# Revision after Peer Review (ID:14828870)-Flood Modelling due to Dam Failure Using HEC-RAS 2D with GIS Overlay: Case Study of Karalloe Dam in South Sulawesi Province Indonesia

Manuscript Title: **Flood Modelling due to Dam Failure Using HEC-RAS 2D with GIS Overlay: Case Study of Karalloe Dam in South Sulawesi Province Indonesia**

## Cover Letter-Revision Notes

Figure 1. Fracture parameter overview

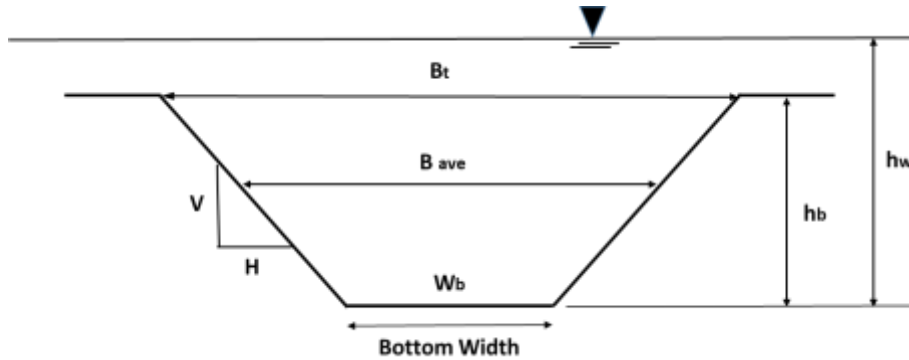
2. Figures 1-3, figure 5, figure 6, figure 8 and figure 9 are unclear. Please provide us the figures with high resolution to allow for reading the details of them. And make sure that all lines and lettering within the figures are legible at final size.
